**Re: 6011 Greenwich Windpark, LLC
OPSB Case No. 13-990-EL-BGN**

Responses to Data Requests and Interrogatories – Set #1

6011 Greenwich Windpark, LLC
Case No. 13-0990-EL-BGN

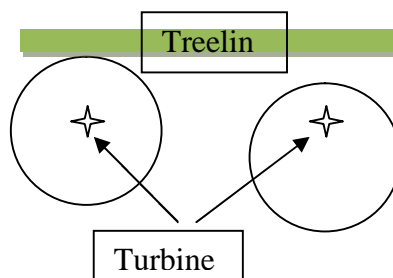
24. It states on p.174 of the application that the Applicant would utilize temporary bridging or a crossing “in the dry” as low impact stream crossing techniques. Please clarify how streams would be crossed to reduce stream impacts, specifically describing best management practices such as matting or bridging to avoid in-stream disturbance.

Should the final site layout require stream crossings, the Applicant would utilize a variety of stream crossing techniques (that would reduce stream impacts), dependent upon the individual stream characteristics and the Project infrastructure component being constructed. Possible practices to be utilized could include wood mats, temporary culverts, and temporary bridges.

Upon consulting with our constructor, their previous Ohio construction experience preference is to place a culvert in the ditch, fill the top with sand, stone and crane mats. After a crane crosses, the mats, stone, sand and culverts would be removed. Seed blankets would then be placed on the banks of the ditches for erosion control after everything is removed. The crossings are planned out well ahead of time and reviewed with the county drain authorities and with the road commission(s). (Given that some ditch crossing may have an adjacent road crossing, some jurisdictions require permits for all crossings, while others just want to be notified when a crossing occurs to inspect the condition of the drain before and after the crossing.)
